# Frame Stage Inspection Report

77 Guroman Drive, Greenbank, Queensland, 4124 Australia

**Frame Stage Inspection Report - SDA STAGE - Frame Stage Inspection Report** 22 Apr 2025

| Report Number:                                | ABI-02472   |

Photos of Defects

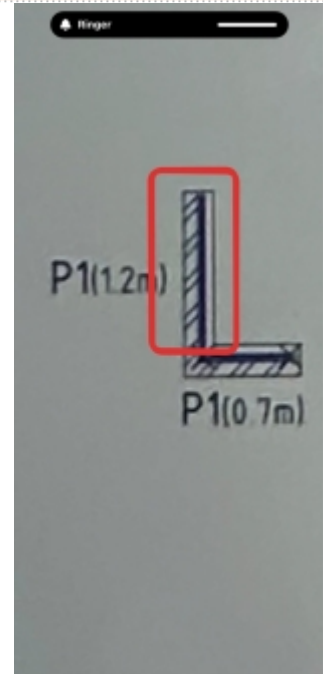
Enter question... Missing playwood bracing to the master bedroom. Needs installing.

Photos of Defects

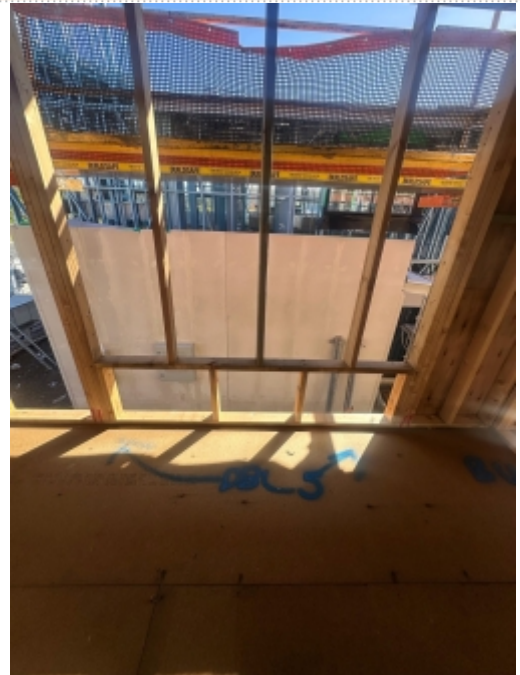
Missing tie-down rod to parts. Recommend engaging a qualified carpenter for future advice on rectification.
